REGULAR MEETING OF THE PLAN COMMISSION OF THE VILLAGE OF WILLOWBROOK TO BE HELD ON WEDNESDAY, JULY 1, 2015 AT 7:00 P.M. AT THE VILLAGE HALL, 7760 QUINCY STREET, IN THE VILLAGE OF WILLOWBROOK, DUPAGE COUNTY, ILLINOIS

Prepared By: Jo Ellen Charlton, Planning Consultant

Case Title: PUD Concept Plan Review; The Willows (Pete's Fresh Market; 840 Plainfield Road

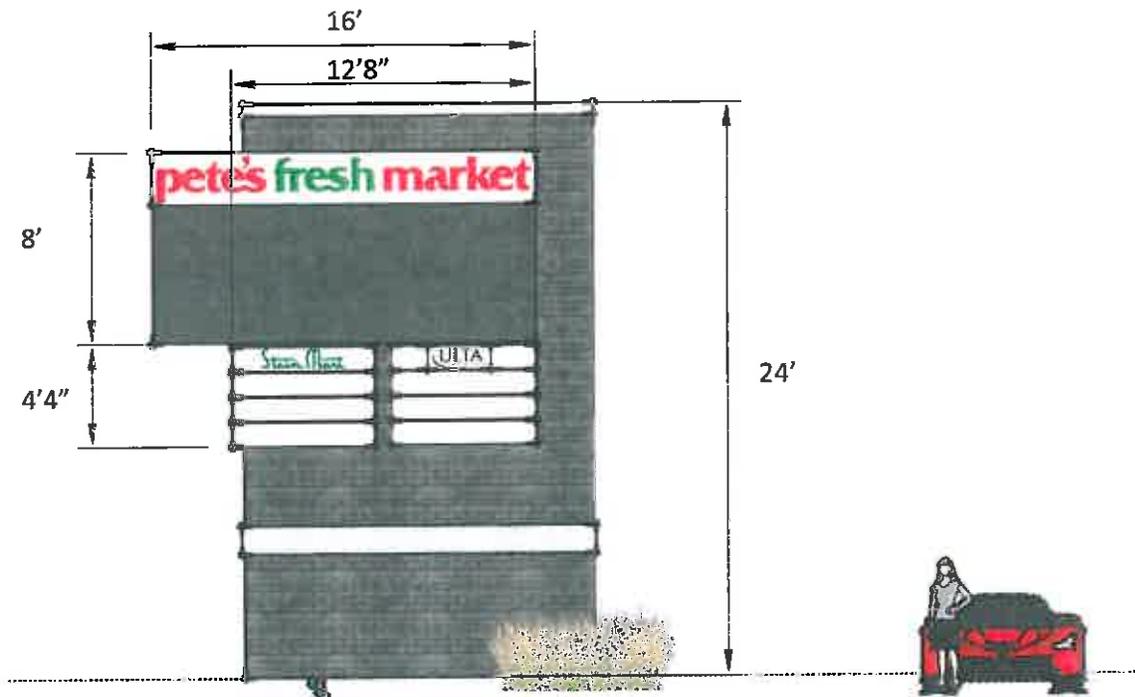
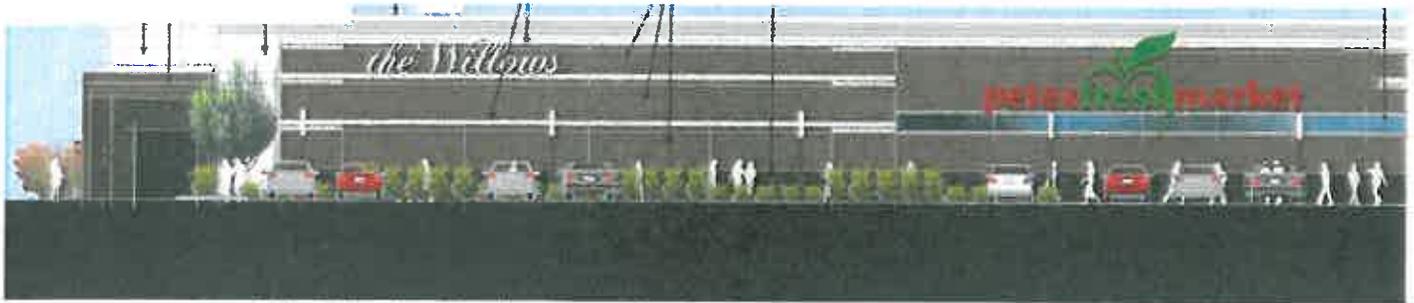
Plainfield Road (starting at east end and moving west)

1. Add new sidewalk north side of Plainfield all the way to Route 83.
2. Add west bound to north right turn into new shopping center. Developer is coordinating with bank property on possible relocation/consolidation of their driveway entrances since the taper for this improvement begins in front of their property. The bank property currently has two entrances, neither of which operates without interference from the signal that already exists as Route 83. The proposed new signal will be much close to their entrances.

3. Add traffic and pedestrian signals and crosswalks at Town Center/Willows entrance.
4. West bound Plainfield to north bound Route 83 right turn lane to be expanded so that it begins at new signalized Plainfield Road entrance. This new lane will impact the corner gas station property adjoining the development site.

5. West bound Plainfield to south bound Route 83 turn lane to be increased from one lane to two lanes with roughly the same queue length. Increased pavement width required on north in front of gas station to accommodate new lanes.

6. East bound Plainfield to north bound Route 83 turn lane to be increased from one lane to two lanes with queue length extended west past Crest. The County is requiring a new barrier median which will no longer allow north bound Crest to west bound Plainfield left turning movements. Increased pavement width required on north in front of gas station to accommodate new lane. New taper extends west all the way past first two houses on the north side of Plainfield

1. Developer proposing modification of the existing north bound Route 83 to east bound Plainfield right turn lane to become a through lane only, creating 3 through lanes of north bound Route 83 traffic along the entire project. Although not yet shown, IDOT correspondence is requesting/requiring the installation of a new north bound Route 83 to east bound Plainfield right turn lane. Applicant is working with IDOT to eliminate that requirement.
2. Slight modification to Route 83 median on south side of intersection to better accommodate west bound Plainfield to south bound Route 83 turning movements from new dual left turn lanes.
3. Installation of a new north bound to west bound turn lane to 69th.

4. Installation of a new south bound to east bound turn lane at 69th into the shopping center. This access is planned on property owned by the office condominium property to the north. Approval from that owner as well as an amendment to their PUD is required from the Village in order to implement this proposed improvement.

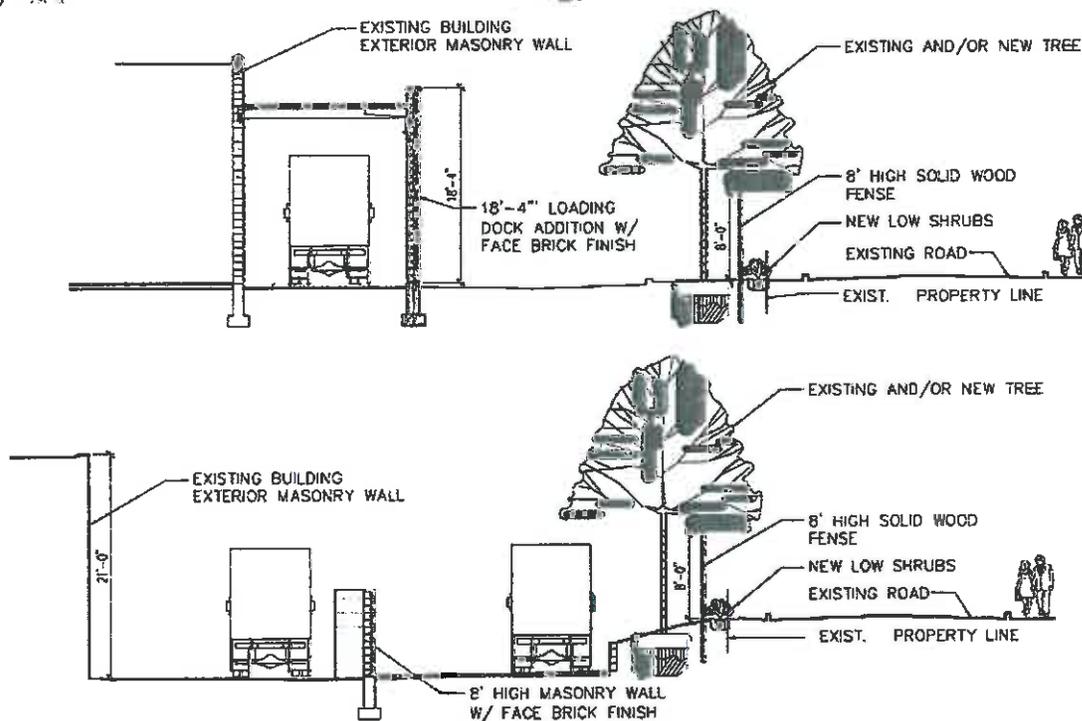
1. Petes gets the maximum of 550 square feet based on “business site frontage”. Current net is 640.2. This absolute maximum should not be exceeded.
2. Steinmart gets 186 based on frontage. Current net is 189.
3. Ultra gets 140. Current net for both signs is 143.
4. The outlot building as a whole is within the overall square footage allowed, although the nails, the Smoothie King and Firehouse Subs are all larger than allowed by their frontage. Given the relative uniformity of the signs, this will be supported, however no “irregularities” will be allowed. Each tenant space will be limited to the square footage indicated in “gross” figures only.
5. No tenant ID signs will be allowed on the rear entrance door of the outlot building as indicated on the Building Signage Plans.

6. Additional information is required for the "Retail Center Graphic Panels". These may or may not be allowed.
7. Plans will not be accepted for the public hearing with any reference TBD or to be determined. The plans will need to be modified to provide specific data for the proposed "retail center identity sign" on the west and east elevations. The top and bottom elevation of these signs should fit within (not cover) the boundaries of any architectural banding. In other words, the light colored "Willows" sign should be sized to fit within the darker brick area.

8. Additional information is needed for the meshy panels utilized on the southwest corner of the Pete's building. Is this signage?
9. The plans must be revised to provide height and width dimensions for all components of odd shaped signs. For example, the height of the Pete's letters must be provided separate from the overall gross height for the two sizes.

L-1

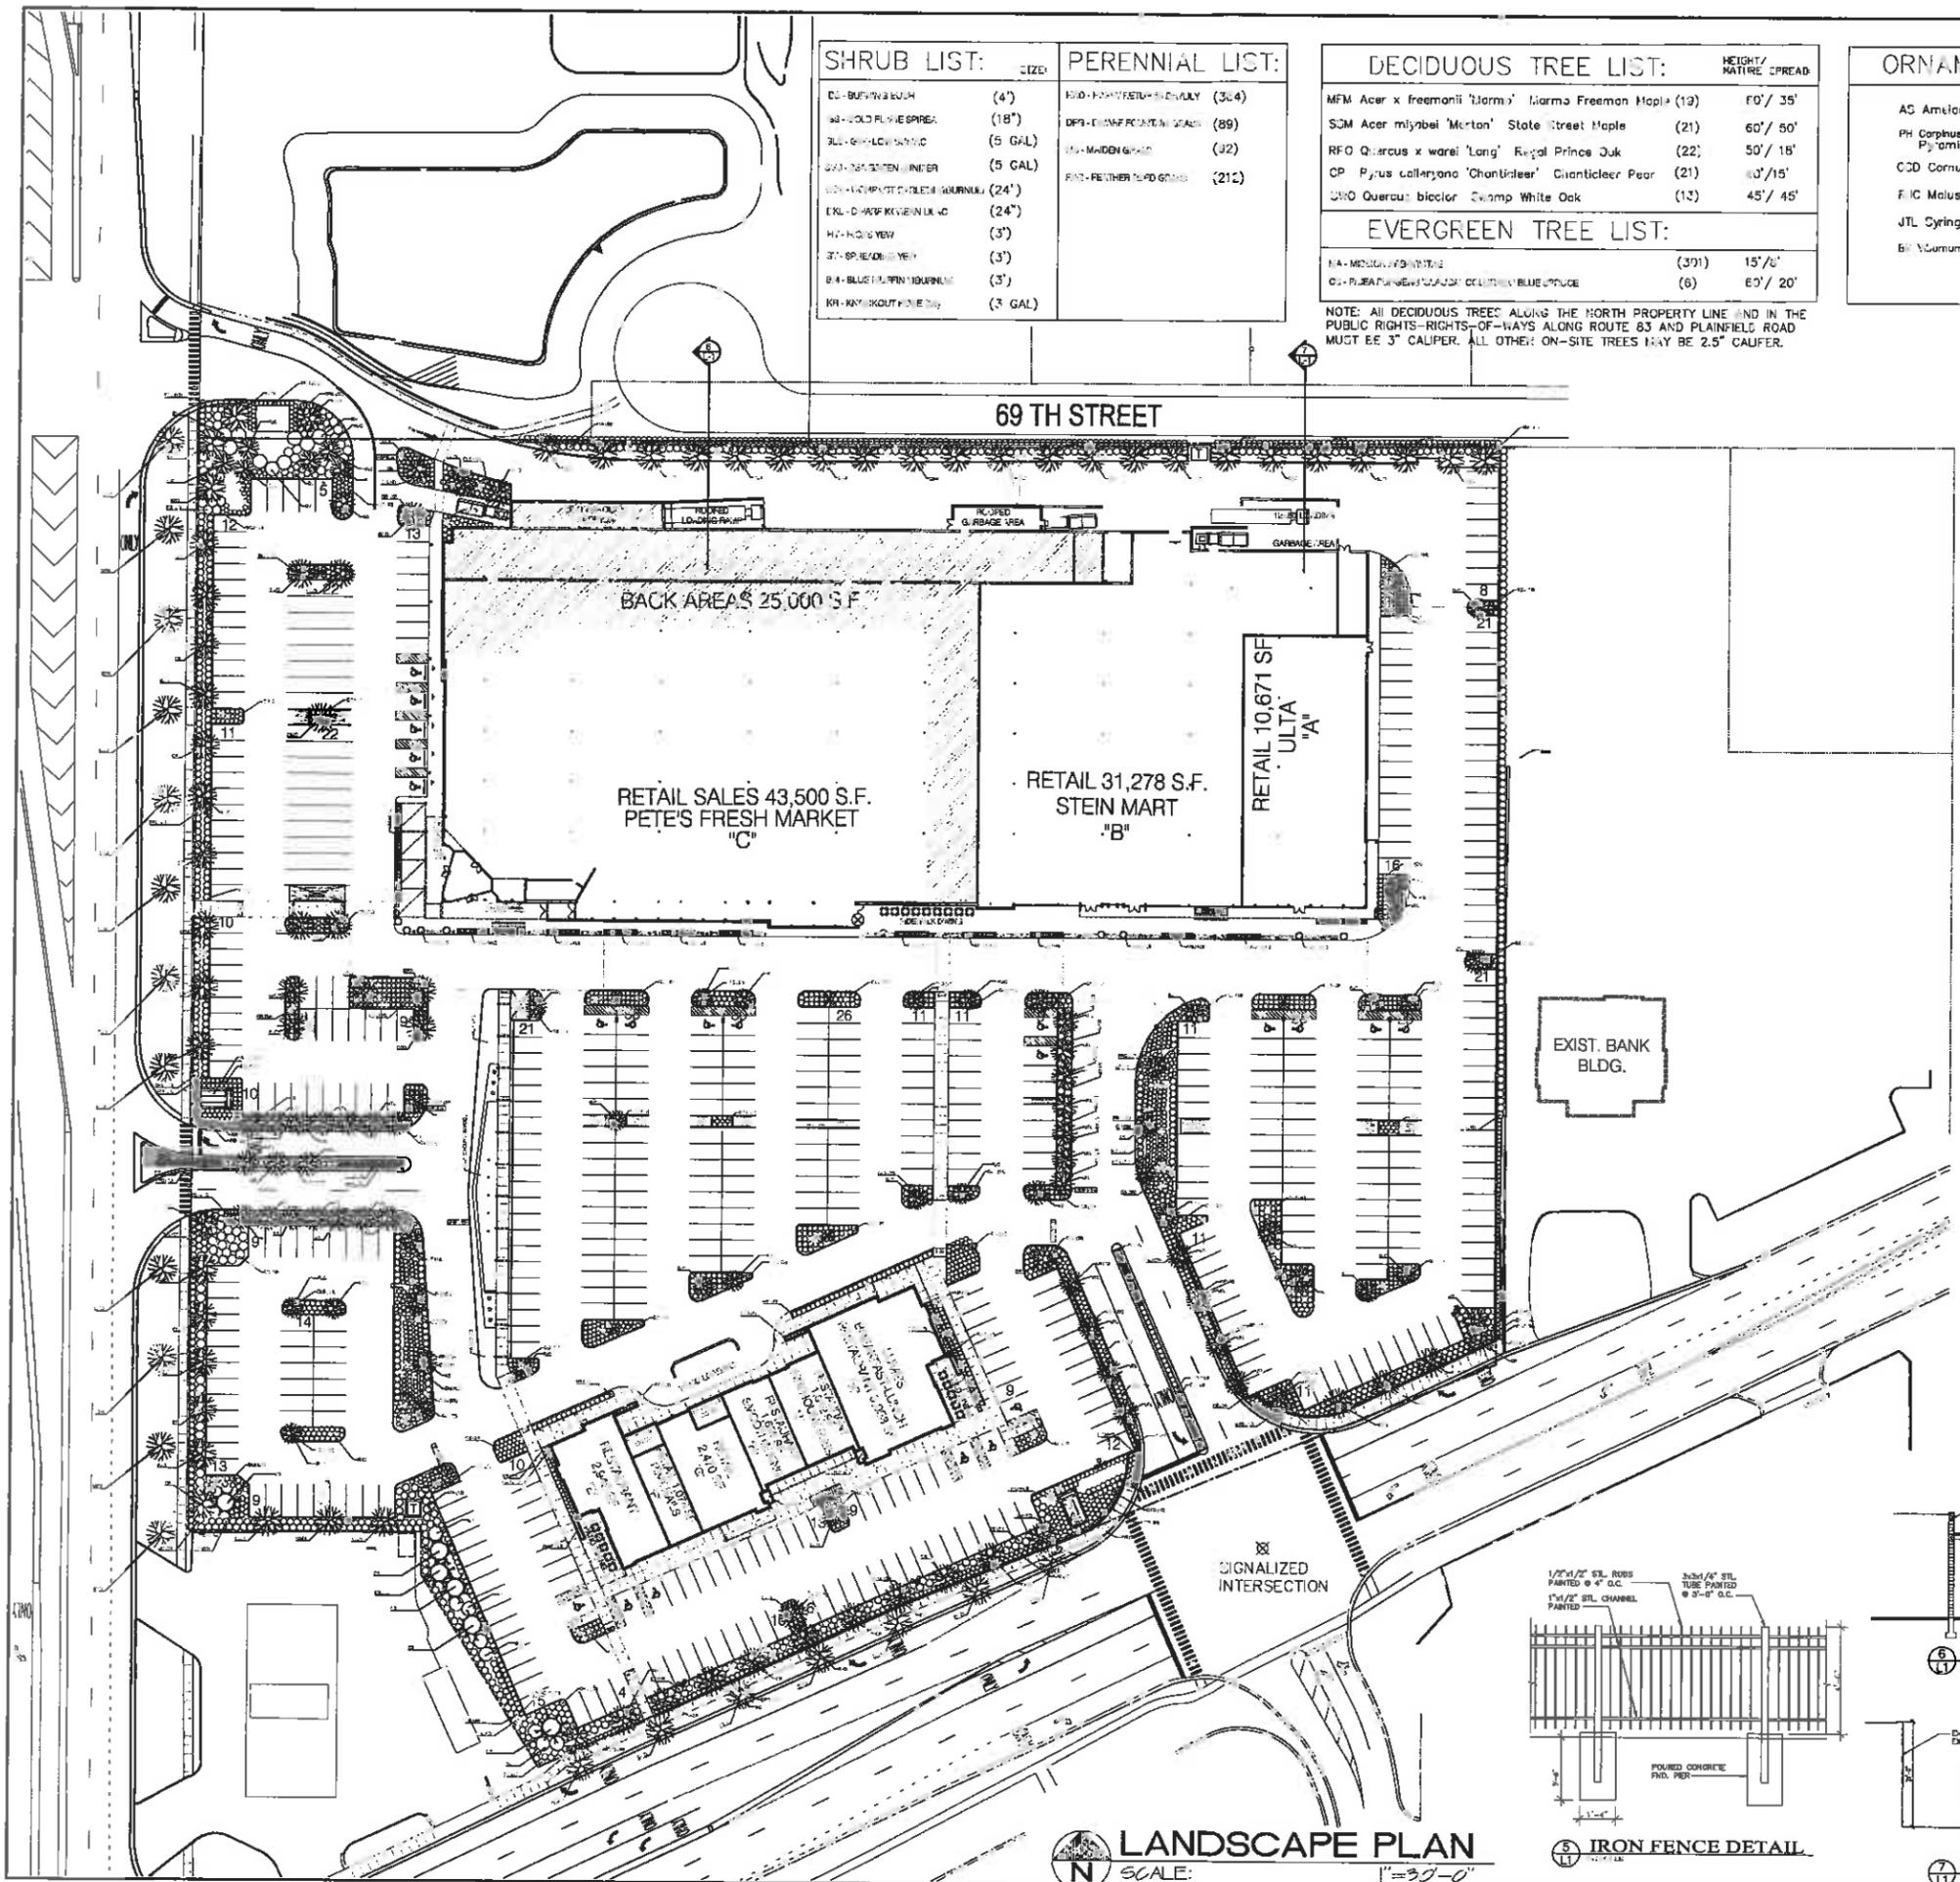
Generally, the landscape plan has been reviewed and has been found to comply as possible given the setbacks provided. Additional improvements and screening still need to be received for the 69th Street entrance, and will be reviewed at that time. Staff will be forwarding comments requiring certain documentation for the proposed landscaping be added to the plans. Additional details are needed for the proposed "water fountain pool" shown at the central Route 83 entrance.

Note the detail provided in the bottom right section of Sheet L1, also provided below.

At the west end, shown in the top picture, the grades on the north and south sides of the fence are nearly the same, which is why the loading dock for Pete’s grocery store in that area is enclosed. Pete’s also gets more deliveries than Steinmart or Ulta. At the east end, shown in the bottom picture, the elevation of the street on the north side of the fence is higher, so the proposed fence screens trucks without having to enclose the loading areas.
